<b>Permit Numl</b>	ber: C-1981-018
<b>Mine Name:</b>	Deserado Mine

**Operator:** Blue Mountain Energy, Inc.

Inspection Start Date: November 3, 2021 Inspection Start Time: 11:10 Inspection End Date: November 3, 2021 Inspection End Time: 12:50		Inspection Type: Coal Partial Inspection Inspection Reason: Normal I&E Program Weather: Clear			
Joint Inspection Agency:		Joint	Joint Inspection Contacts:		
None		None			
Post Inspection Agency:		Post Inspection Contacts:			
None		None			
Inspector(s):	Inspector's Signature:		gnature:	Signature Date:	
Clayton Wein	Clay	Tan a	Wein	11/8/2021

**Photo 1:** The outlet of the DP-1 Pond.

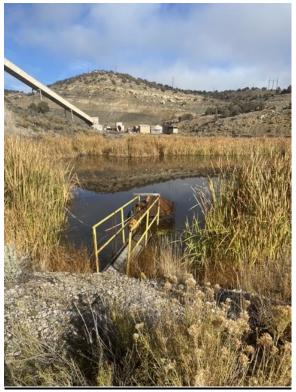
The three ponds located at the main facilities area were inspected. The DP-1 pond is located on the lower bench. The pond treats all runoff from the main facilities area. The pond was impounding water during the inspection. Discharge from the primary spillway was observed (Photo 1). The trash rack on the spillway was clear of debris and in good repair. The embankment for the pond was stable with vegetative cover. There were no indications of erosion. The PP-1 pond is located on the middle bench within the prep plant facility. The pond was holding some water. The pond had been cleaned since the previous Division inspection. The embankments were stable with no erosional features noted. There was no discharge from the pond. The PP-2 pond is located on the upper facilities bench. The pond was holding water and covered with algae. The outlet for the pond was unobstructed, with no discharge. The embankment was vegetated and stable. There were no erosional features identified.
